# Access Compliance Report

## Public Rights-of-Way

### (Pedestrian Signals)

Intersection ID: N/A	Main Street:	Cross Street: N/A	Location: N/A
ADA ID: 9B781D2EF5FB	Signal Type: One Push Button-Non APS	Overall Compliance: No	Severity Score: BTN 1: N/A BTN 2: N/A No BTN: N/A
Codes/Mitigation Info/Possible Solution		Field Measurements/Component Compliance

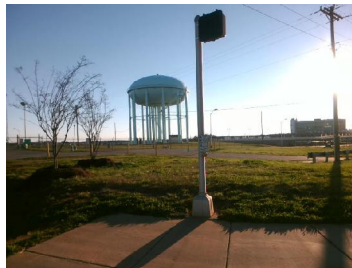
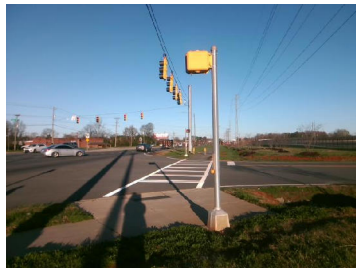
PROW/ADA: TMUTCD 4e.08, R404.2, R404.3, R404.7.2

N/A	B 1 Clear Xing Direction?	Yes	N/A	B 2 Clear Xing Direction?	N/A
	B 1 Crossing Direction	To NW		B 2 Crossing Direction	N/A
Yes	B 1 DistanceTo XWalk (in)	24.0	N/A	B 2 DistanceTo XWalk (in)	N/A
No	B 1 DistanceTo Curb (in)	171.0	N/A	B 2 DistanceTo Curb (in)	N/A
Yes	B 1 Diameter (in)	2.0	N/A	B 2 Diameter (in)	N/A

Possible Solutions: Replace Signal Push Button With APS Button on New Post. Remove & Relocate Sign.
